* * S4BA * * * * * , * * * * * S4B * * * * * .

S4BA * * * * * :

* * L * * * *

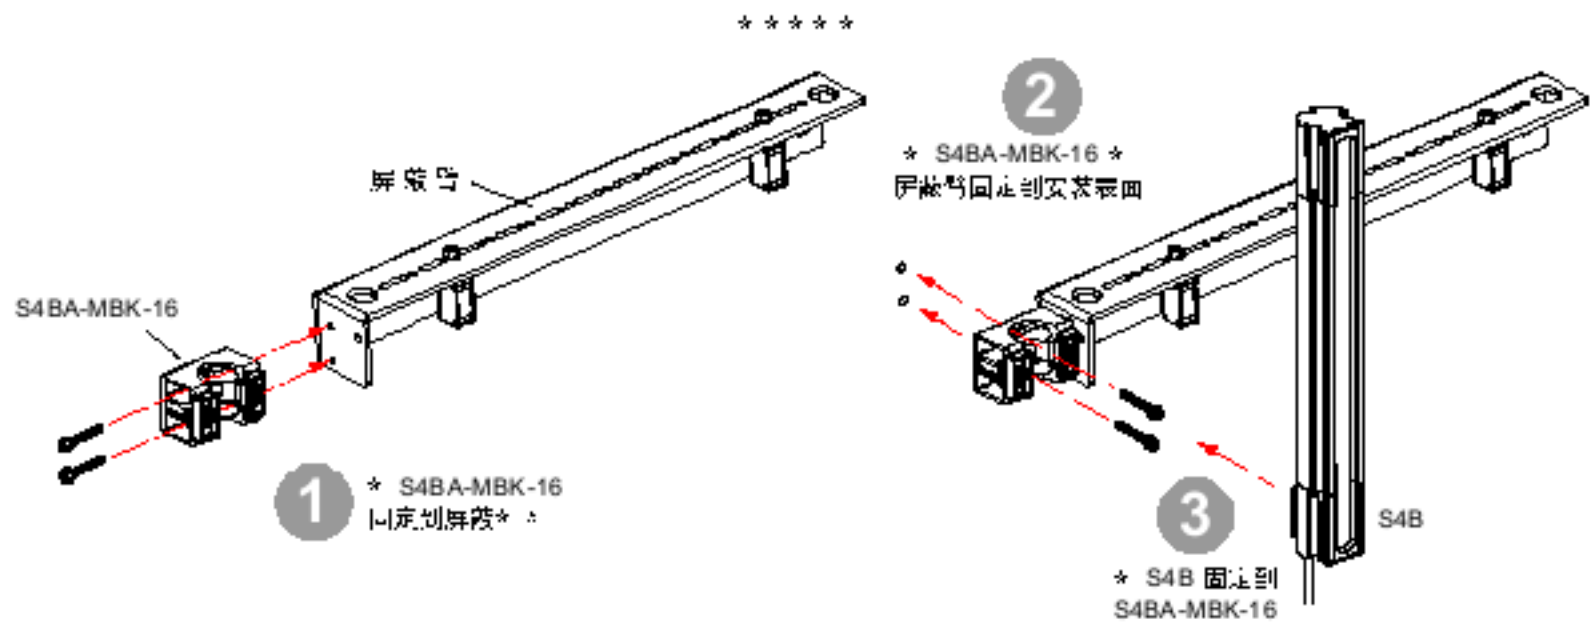
* * * S4BA-MBK-16 * * * .

1. * * * * * S4B * * (* * * 230287) * * * * * .
2. * * * * * S4BA-MBK-16 * * * * * , * * S4BA-MBK-16 * * * * * . * * * * * S4B * * * , * * * * * .

(1) * * * * * .
(2) * * * * * .

3. ***** M4 *****。
4. * S4B *****，** S4B *****。
5. ***** Q20-2 *****。

*** 1 : *** S4B **

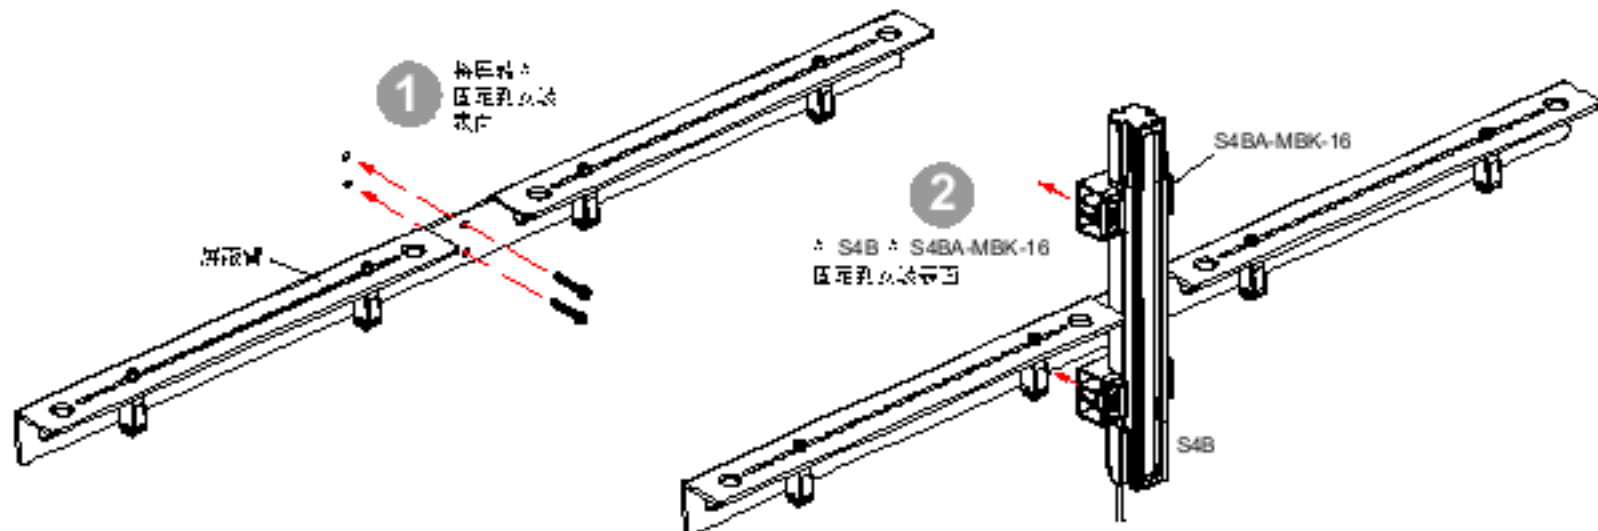
* T ** X ***** S4BA-MBK-16 *****，*****。*****。

1. ***** S4B ** (*** 230287) *****。
2. ***** S4BA-MBK-16 *****，***** S4BA-MBK-16 *****。

3. ***** S4B *****。
4. * S4BA-MBK-16 ***** (*****，*****)。
5. ***** Q20-2 *****。

*** 2 : *** S4BA-MBK-16 **

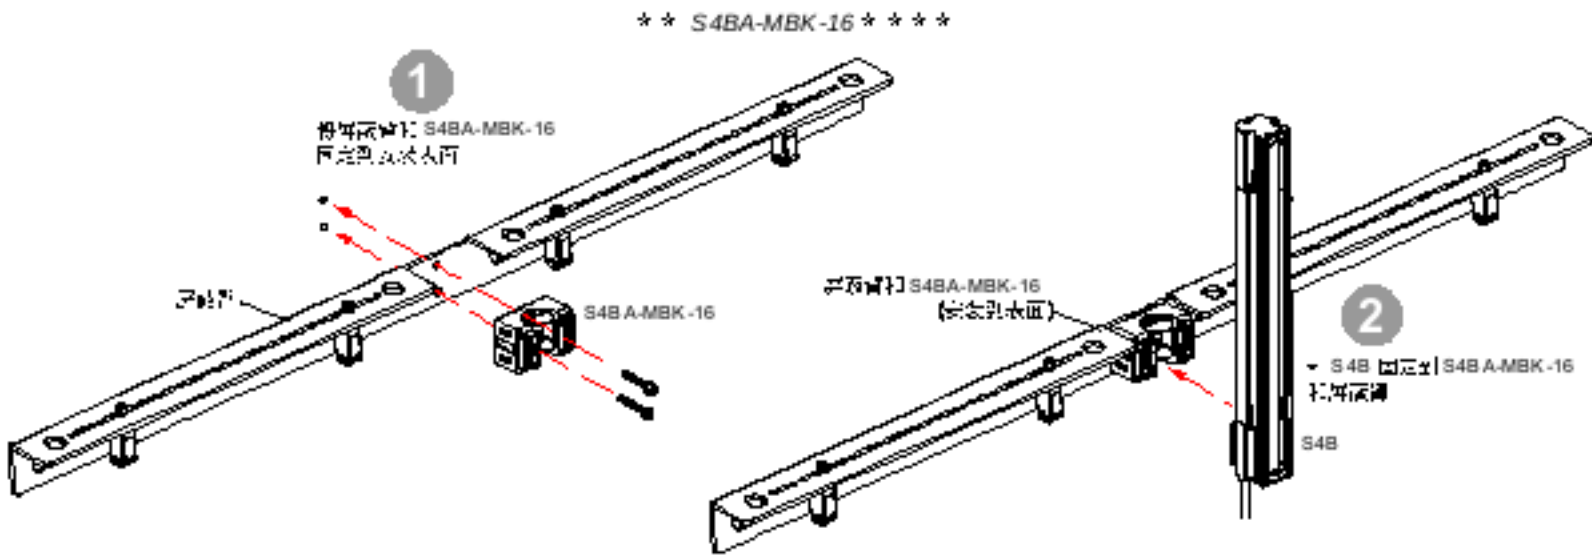
1. ***** S4B ** (*** 230287) *****。
2. ***** S4BA-MBK-16 *****，***** S4BA-MBK-16 *****。

- 3. *** S4BA-MBK-16 *****, ** S4BA-MBK-16 *****, ****.
- 4. **** S4BA-MBK-16 *****, ****, ****.
- 5. * S4B *****, ** S4B ****.
- 6. **** Q20-2 ****.
